Addendum #1

IFB 50018-260020 Holland Hall Laundry Room

WATER LINE LOCATIONS
 NEW 1/2" WATER LINE
 CONNECTION - OPTIONS
 FOR CONNECTION

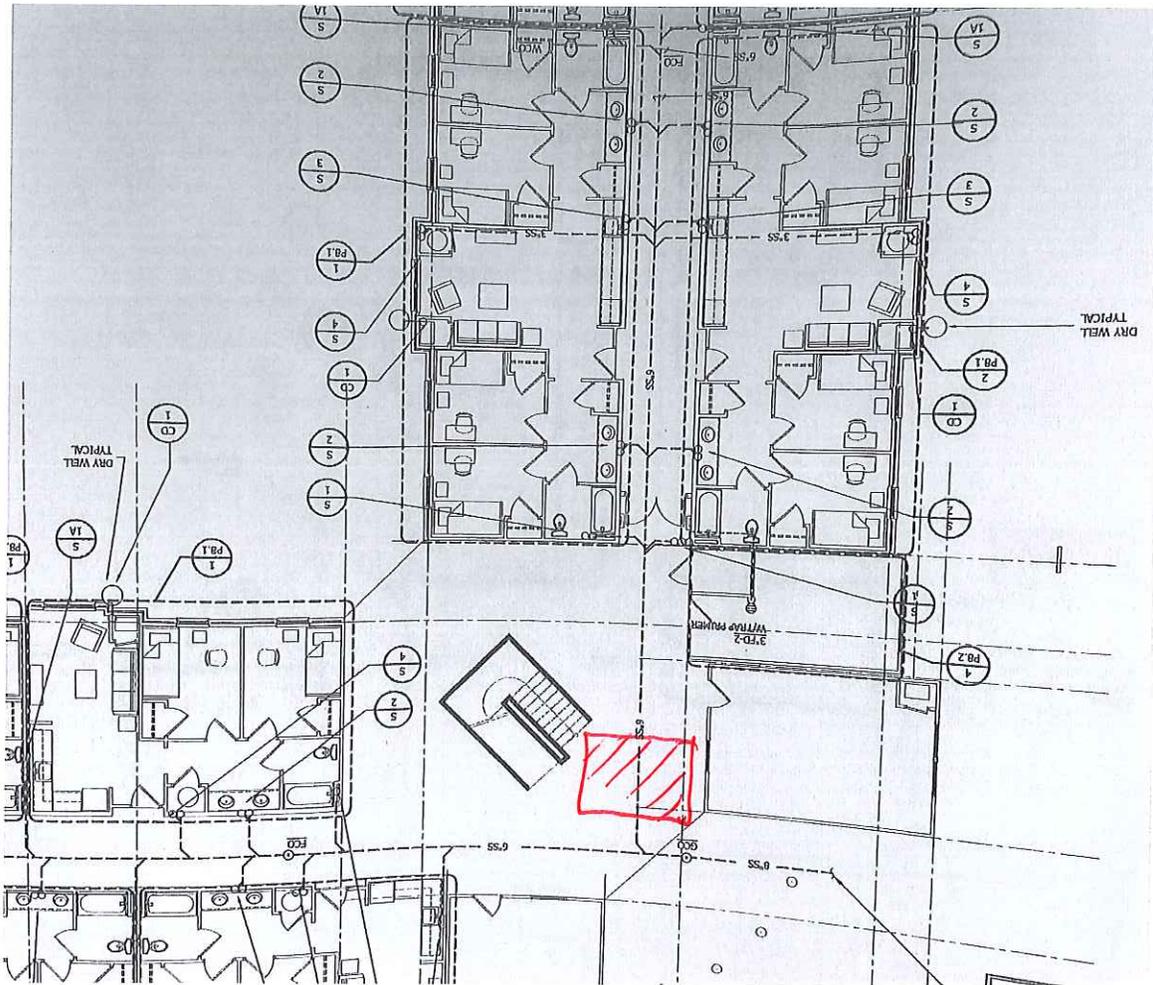
SEWER MAIN
 CONNECTION AREA
 ASSUMED TO BE
 ABOUT SEVEN FEET (7')
 BELOW SLAB AT THIS
 LOCATION
 NOTE EXISTING VEST LOCATIONS
EXISTING SEWER MAIN
HOLLAND HALL
